AMENDMENT #3
11-10-22
Invitation for Bids (IFB) Number
GC-21-WCW1Upgrade-01, 10/19/2021
Issued by
Gillespie County Water Control and
Improvement District #1
Fredericksburg, Texas

Amendment No. 3 (11-10-22)
IFB No. GC-21-WCW1Upgrade-01 (Site 1 Upgrade)

GENERAL NOTES
 FLOODWATER RETARDING STRUCTURE SITE No. 1 UPGRADE OF THE
 WILLIAMS CREEK WATERSHED
 IN
 BLANCO, GILLESPIE, & KENDALL COUNTIES, TEXAS

EMBANKMENT TYPICAL SECTIONS
FLOODWATER RETARDING STRUCTURE SITE No. 1 UPGRADE OF THE
WILLIAMS CREEK WATERSHED
IN
BLANCO, GILLESPIE, & KENDALL COUNTIES, TEXAS

GENERAL PLAN
 FLOODWATER RETARDING STRUCTURE SITE No. 1 UPGRADE OF THE
 WILLIAMS CREEK WATERSHED
 IN
 BLANCO, GILLESPIE, & KENDALL COUNTIES, TEXAS

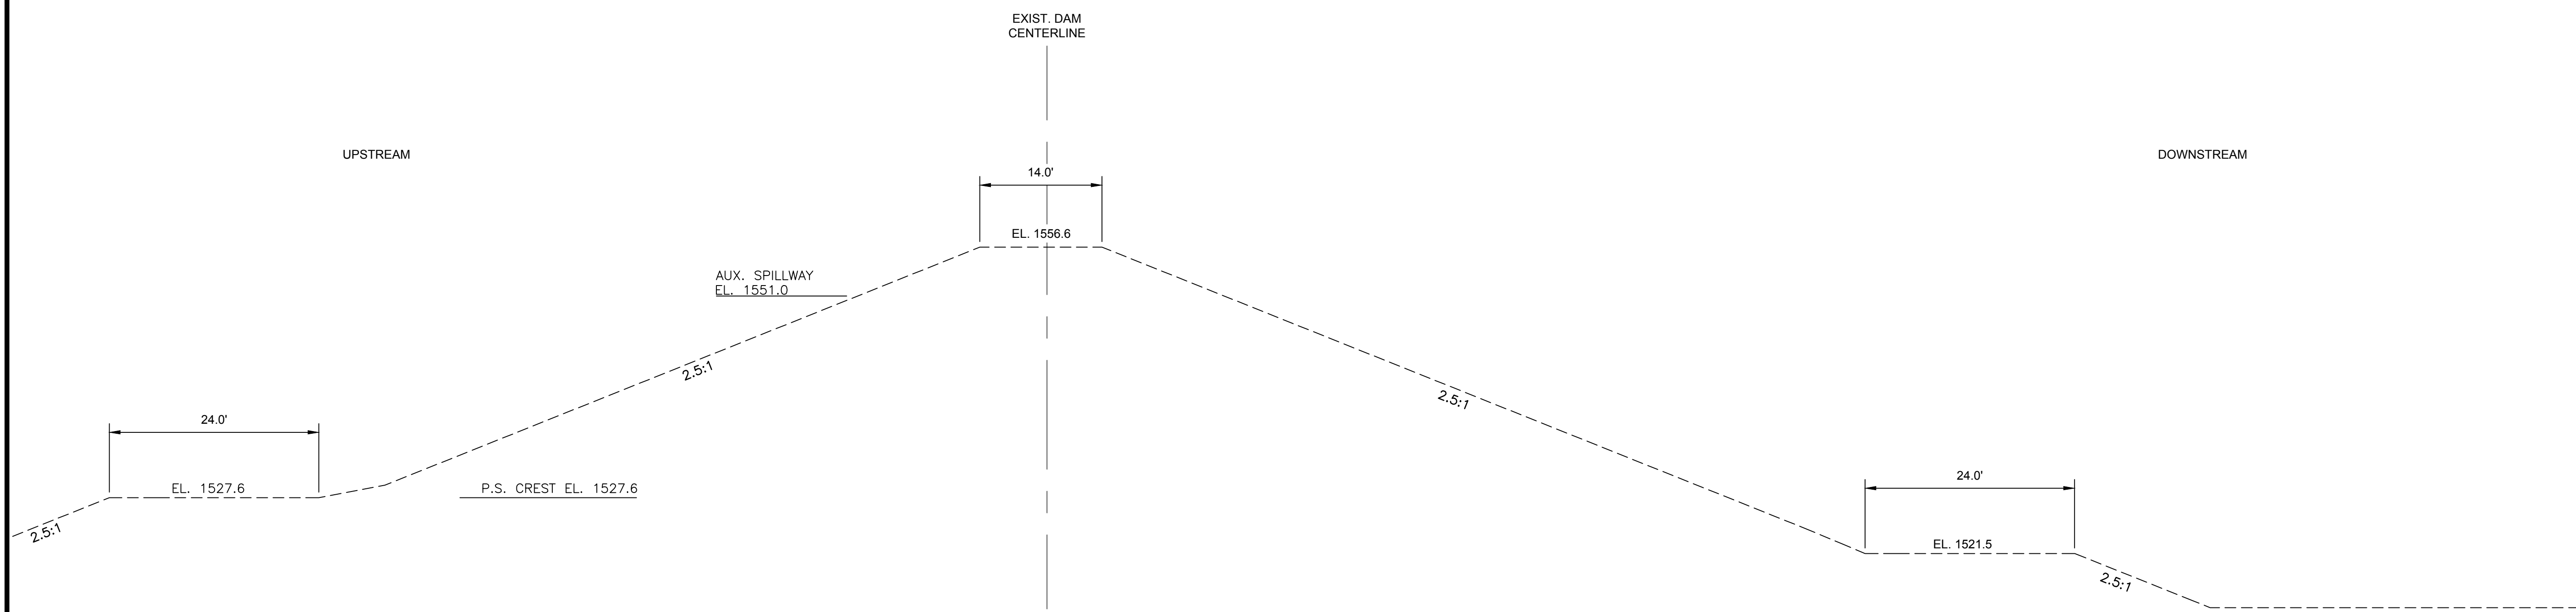
The material specifications for Zone 1 soils have been adjusted to allow the use of soils with a liquid limit less than or equal to 85 within the core of the embankment fill as indicated on the updated typical section on Sheet C-6. The outer shell of the embankment, within the limits designated, shall consist of Zone 1 soils with a liquid limit less than or equal to 70. The material placement data table on Sheet G-2 has been updated accordingly. The borrow area limits shall be extended, if necessary. Final limits of the borrow area shall be approved by the Owner.
